Ocean Ridge Plantation, Phase VI, Section 1

Sunset Beach, NC

COMPLIANCE INVESTIGATION REPORT

October 2014

Phase VI, Section 1 Roadway Exhibit

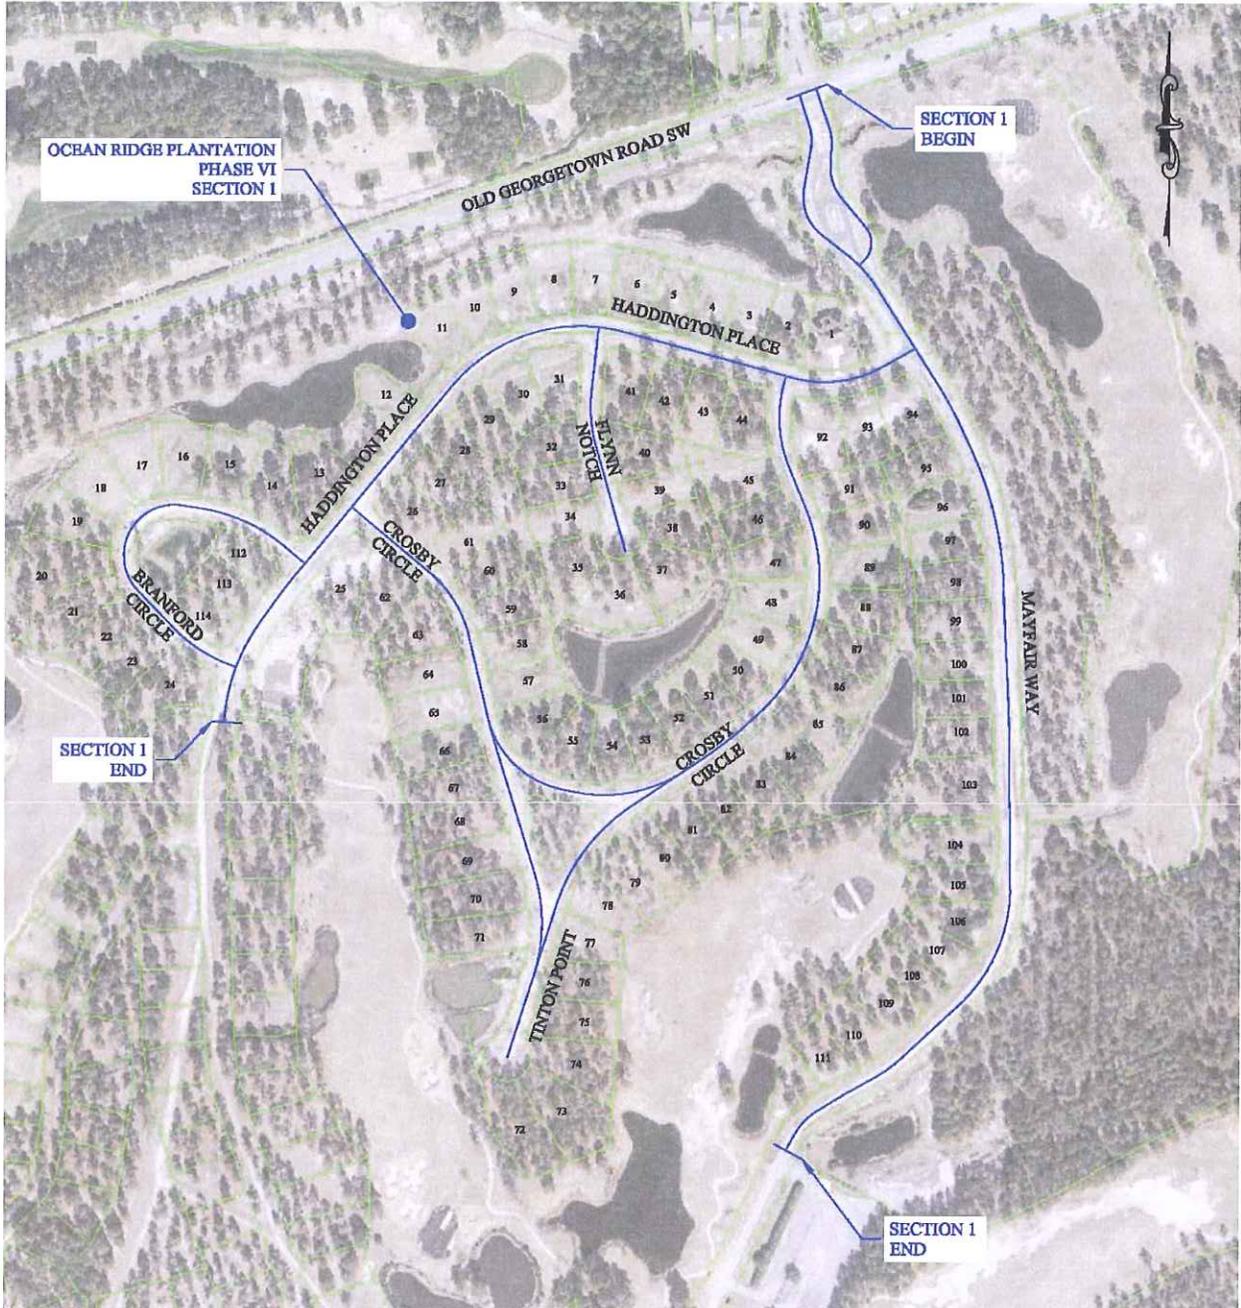
The locations and widths of the roadways appears to be in general conformance with the approved plan with the exception of the southbound lanes of the Boulevard Road Section of Mayfair Way in the area of the guardhouse island where two (2) lanes separated by a curbed median were not constructed in accordance with the approved plan.

Phase VI, Section 1 Core Location Exhibit

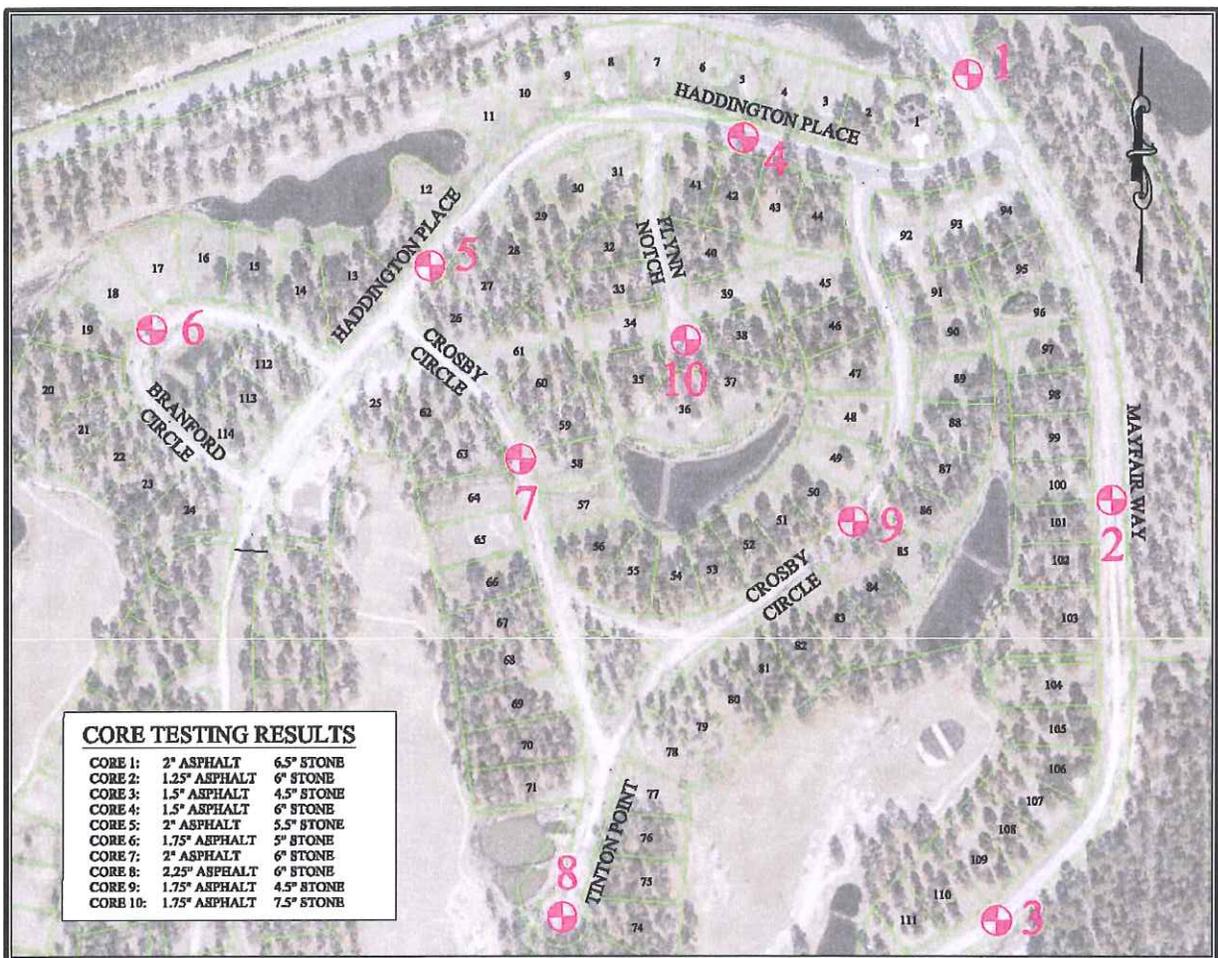
In accordance with Town of Sunset Beach Code of Ordinances 98.15, ten (10) asphalt pavement cores were performed in random test locations throughout the subdivision based on the professional guidance of ECS. The results were compared to the design asphalt pavement section as shown on the approved plans. The results from the core tests determined that four (4) of the cores samples contained insufficient ABC stone thickness – test locations 3, 5, 6, and 9 – and one (1) of the core tests determined that test location 2 contained insufficient asphalt surface course. See the Phase VI, Section 1 Core Location Exhibit below for specific core locations and results.

On October 3, 2014, ECES Staff walked Section 1 of the subdivision with the Town of Sunset Beach Public Works Director and the Ocean Ridge Plantation HOA representative, Becky Nobles. All ten (10) core locations were observed and (9) of the (10) cores appeared to be patched within acceptable NCDOT standards to both ECES Staff and the Town. Ms. Noble declined to comment on the acceptability of the core patching. One (1) core along the east section of Crosby Circle, Core 9, was identified by all those in attendance as requiring additional patch to prevent ponding of stormwater.

Core 9 was subsequently enhanced to meet acceptable NCDOT core patching standards.

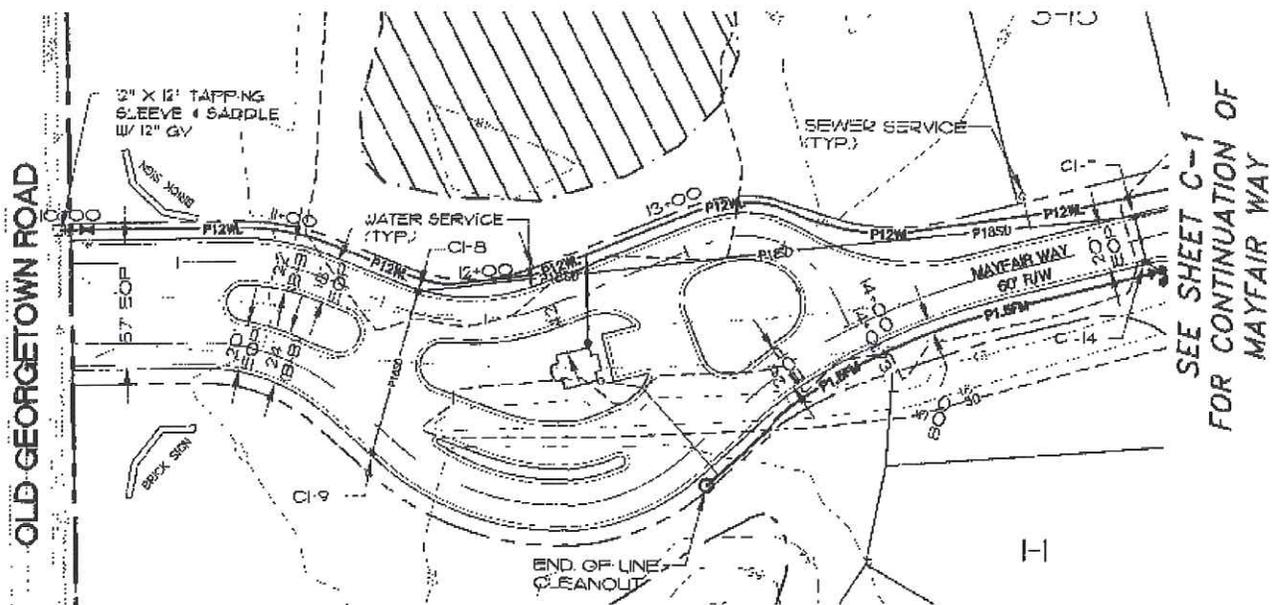
Several roadways throughout the subdivision have gutter pans blocked by sediments and debris. In order for the gutter pan to function in accordance with the approved plan and prevent unnecessary ponding of stormwater on the asphalt roadway, all gutter pans should be checked regularly to make sure that they are free of sediments and debris. Sediment should be removed by →shoveling or sweeping and transported to a sediment controlled disposal area.

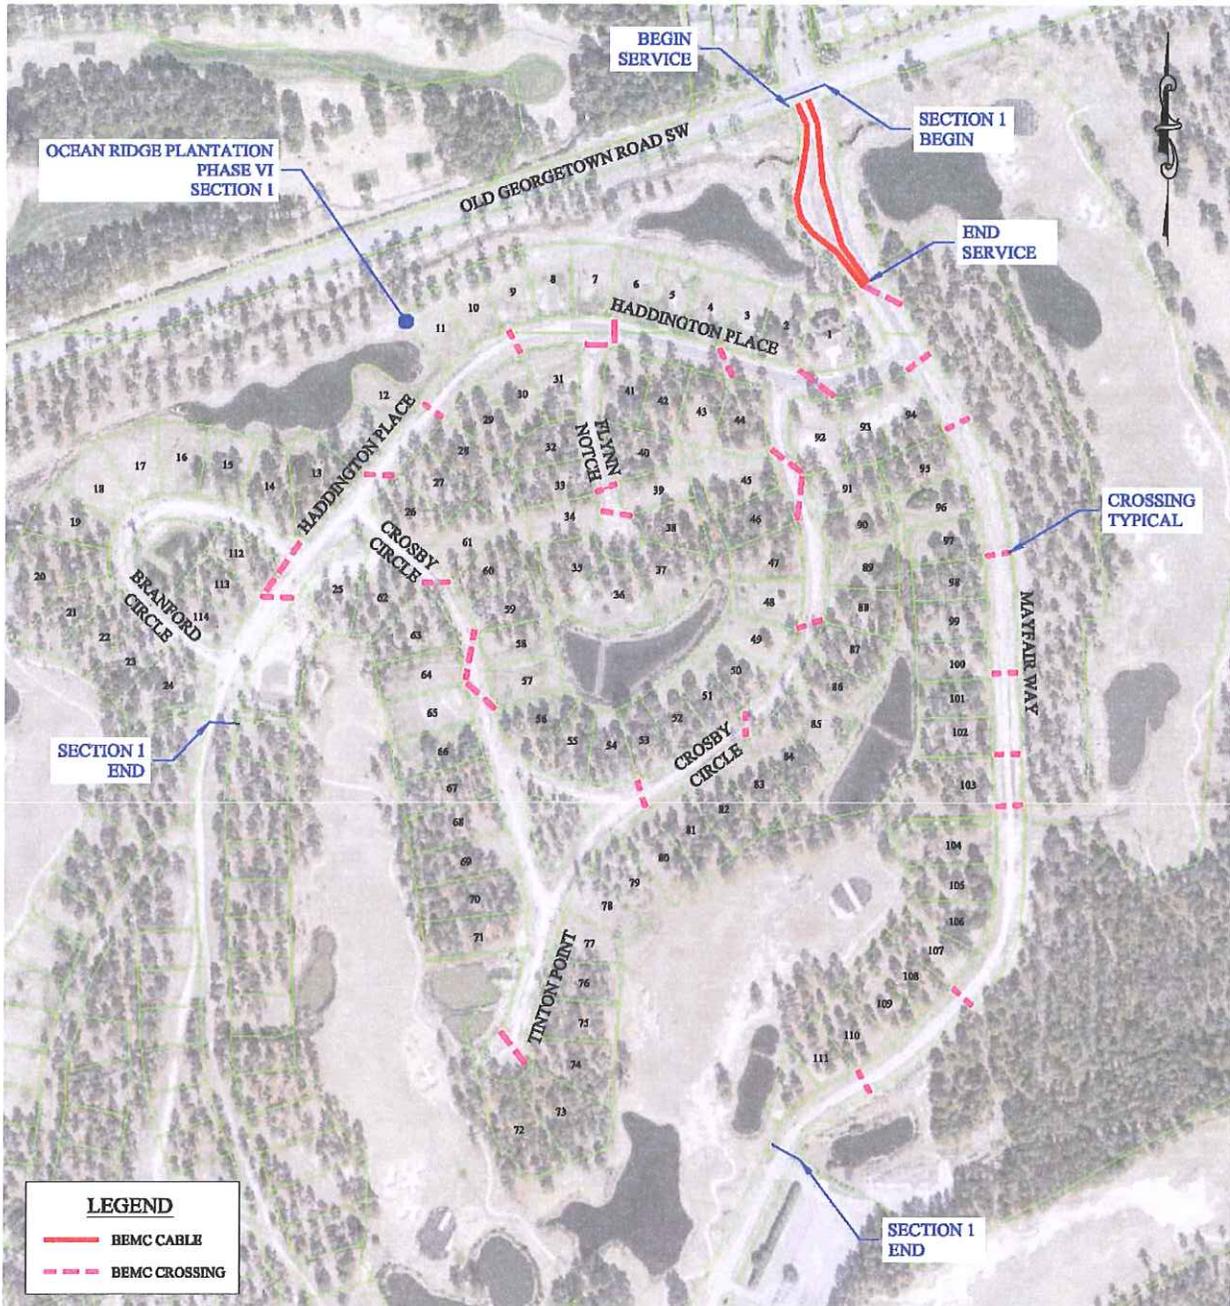
Stormwater Ponds can be used as temporary sediment basins throughout construction as long as they are maintained and function as designed. In accordance with the approved Stormwater Plan by Cape Fear Engineering, Inc. sealed 11/13/08, the sediment shall be removed when the level of sediment deposition reaches 25% of the initial design volume. The silts shall be removed and the design volume restored.

August 2014 field investigations confirm that the level of sediments in several of the ponds far exceed 25% of the initial design volume as bottom elevations were visible from top of bank observations during high water conditions after several periods of heavy rainfall.

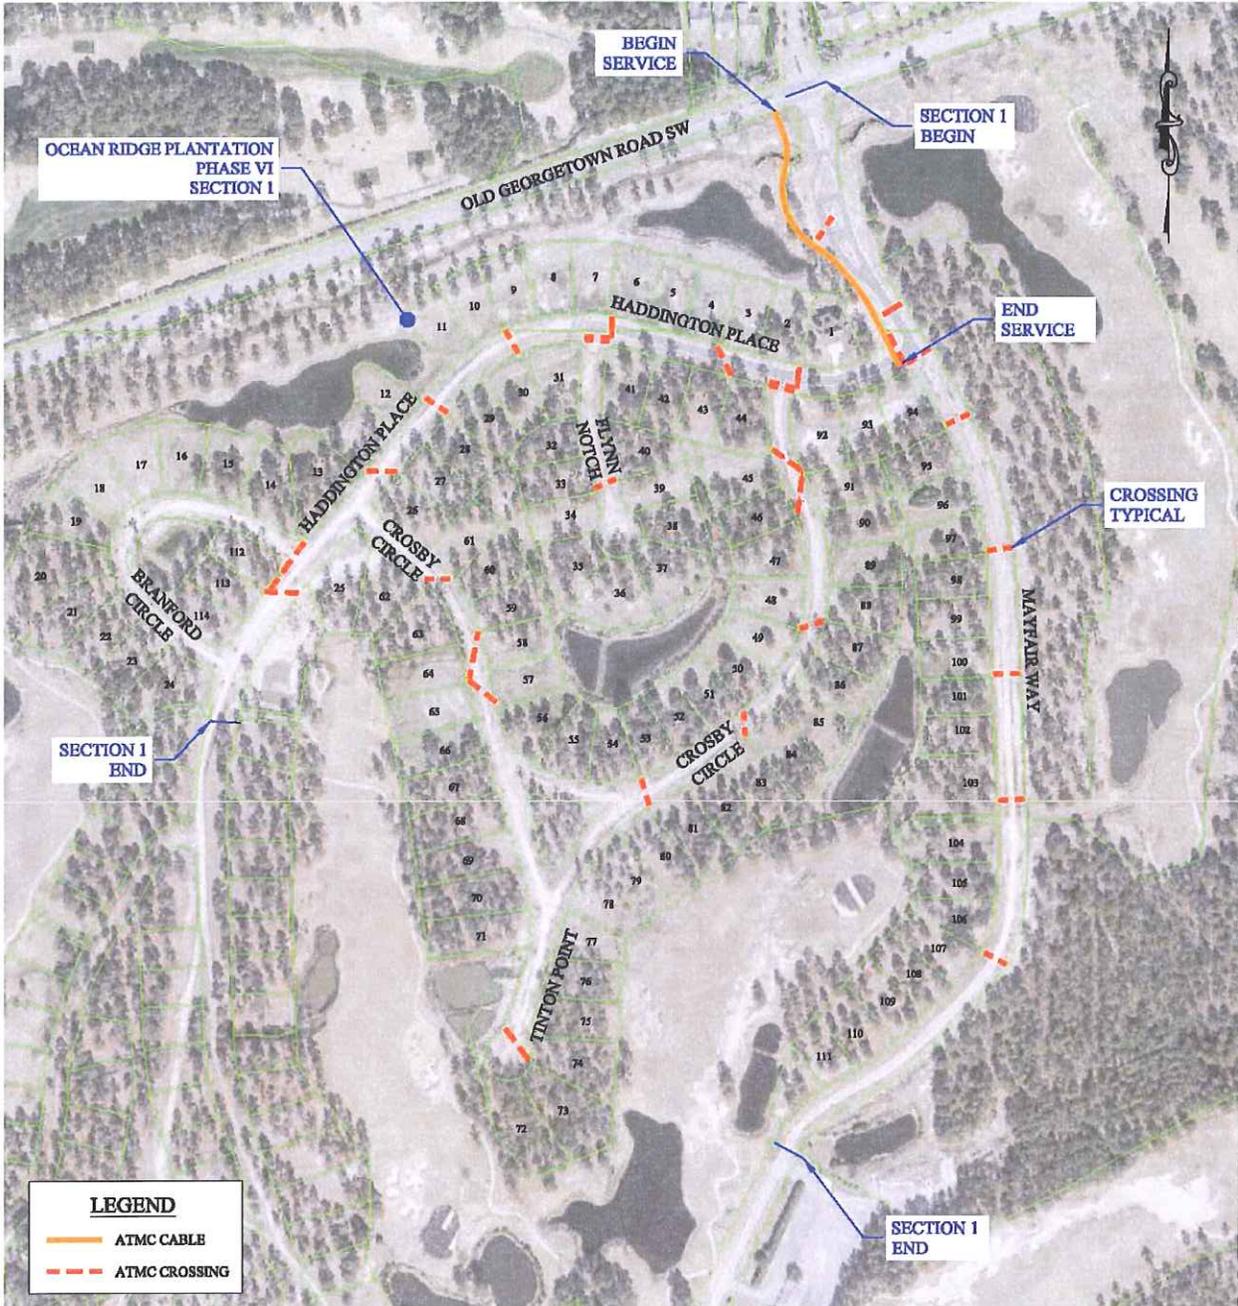
As of the date of this Report, two (2) light poles have been installed within the subdivision right of way.

- Intersection of Mayfair Way and Haddington Place
- Guardhouse island

Although the approved plan does not include a lighting plan, it is in our professional opinion that adequate lighting should be provided throughout the subdivision for the safety of the public.

Pond 2

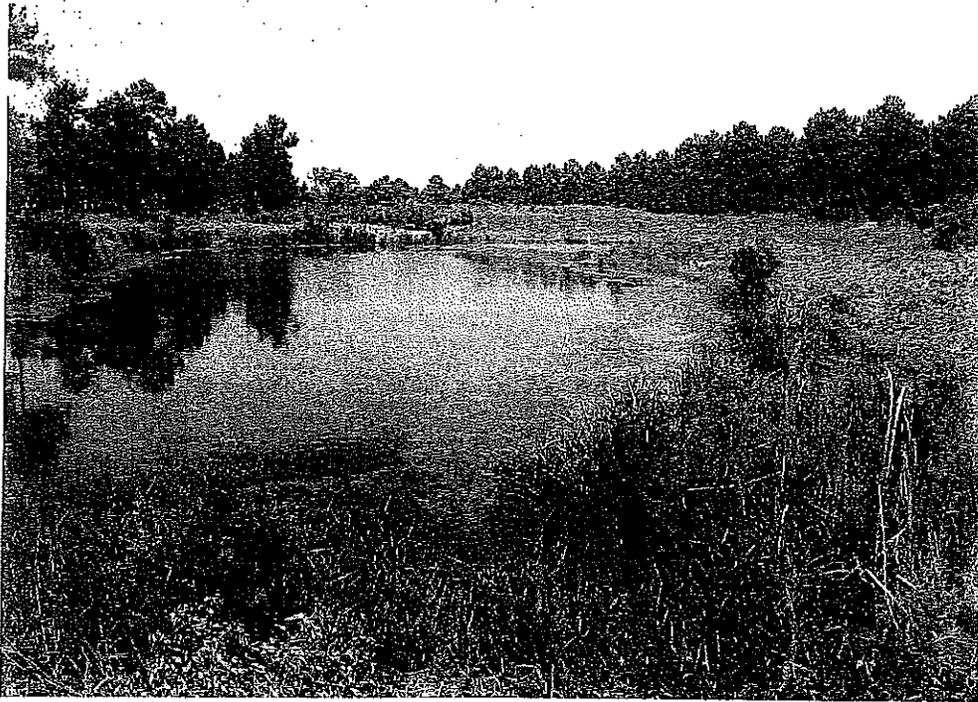
- Comment: Pond 1: Trees and overgrowth on banks. A few areas of erosion. All pond banks to be seeded with grass. Main pond depth to be verified. Pond 2: A few areas of erosion. All pond banks to be seeded with grass. Overall depths to be verified and restored. Pond 3: Same as Pond 2, plus trees and overgrowth on banks. Pond 4: Trees and overgrowth on banks. Many areas of erosion. Bare areas need to be seeded with grass. Overall depths verified and restored. Temporary slope drain should be removed. Pipe from golf course should be permanently capped. Pond 5: Trees and overgrowth on banks. A few areas of erosion need to be repaired. All banks of pond to be seeded with grass. An outlet structure could not be found due to the high water conditions. Overall depths verified and restored. Pond 7: Same as Pond 5. Pond 8: Severe erosion and sedimentation. Many areas of erosion. All pond banks to be seeded with grass. Overall depths verified and restored.
